20PBD

Safety Recall - Certain Model 520 vehicles with Right-Hand Stand-Up ("RHSU") configuration may have incorrect bolts installed on the steering assist cylinder bracket.

Certain Model 520 vehicles with Right-Hand Stand-Up ("RHSU") configuration may have incorrect bolts installed on the steering assist cylinder bracket. NHTSA recall number is 20V429 and Transport Canada recall number is 2020-340.

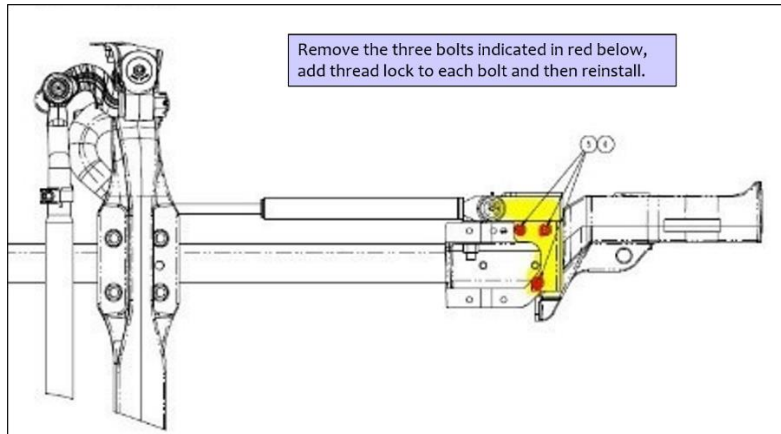
Peterbilt Motors Company has decided a defect which relates to motor vehicle safety may exist in certain Model 520 vehicles with Right-Hand Stand-Up ("RHSU") configuration built between February 15, 2019 and December 20, 2019. Vehicles may have incorrect steering assist cylinder bracket bolts installed, which prevents proper retention of these bolts. The steering assist cylinder bracket attached to the right front spring bracket with these bolts may also be damaged. The bolts installed may not have the required thread lock and this could result in loose or missing hardware. This may cause the bracket to flex or break and cause damage to adjacent components or lock up steering.

1. Locate the steering assist cylinder bracket attached to the right front spring bracket.
2. Remove and reinstall the 3 bolts with Loctite 243 thread locker attaching the bracket to the front spring bracket.
3. Torque (3) M12 bolts to 75 lbft/102 Nm

**Review the image below for bracket and bolt location.**
